## Overview

The purpose of this notification is to communicate a required update to the configuration bitstreams for the Spartan-3™ FPGAs. Please update all XC3S50, XC3S1000, XC3S1500, XC3S2000, XC3S4000, and XC3S5000 FPGA configuration bitstreams using the [Xilinx ISE 6.3i, Service Pack 1 or later](#) software release.

Figure 1: Example Spartan-3 Package Markings

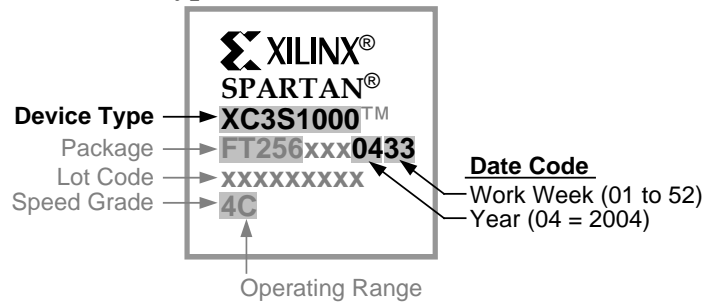
| Date Codes:         | Parts marked with date code “0433” or later (greater). See <a href="#">Figure 1</a> . |

[Figure 1](#) shows an example top marking for a Spartan-3 FPGA. The relevant fields to identify an affected device are highlighted and include the **Device Type** and the **Date Code**.

Figure 2: Spartan-3 Bitstream Update Decision Diagram.

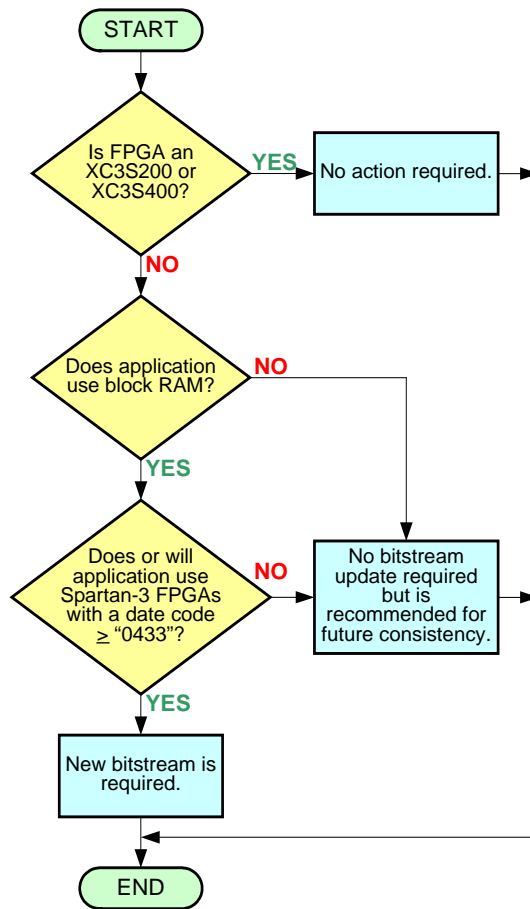
The update, however, is not absolutely mandated for all applications. [Figure 2](#) diagrams the decision process on whether a bitstream update is required for a specific Spartan-3 FPGA. No update is required for XC3S200 or XC3S400 FPGAs. Similarly, if the FPGA application does not use block RAM, a bitstream update is not required but is recommended for future consistency. Likewise, if the FPGA is not an XC3S200 or XC3S400 but has a date code prior to—*i.e.*, less than—“0433”, then an update is recommended, but not required. Finally, all XC3S50, XC3S1000, XC3S1500, XC3S2000, XC3S4000, and XC3S5000 FPGA applications that use block RAM and have or may have a date code of “0433” or later do require the bitstream update.

**Xilinx recommends updating the bitstream for all Spartan-3 FPGAs** using the Xilinx ISE 6.3i, Service Pack 1 software or later. By updating the bitstream, the application can use any existing or future Spartan-3 FPGA device.
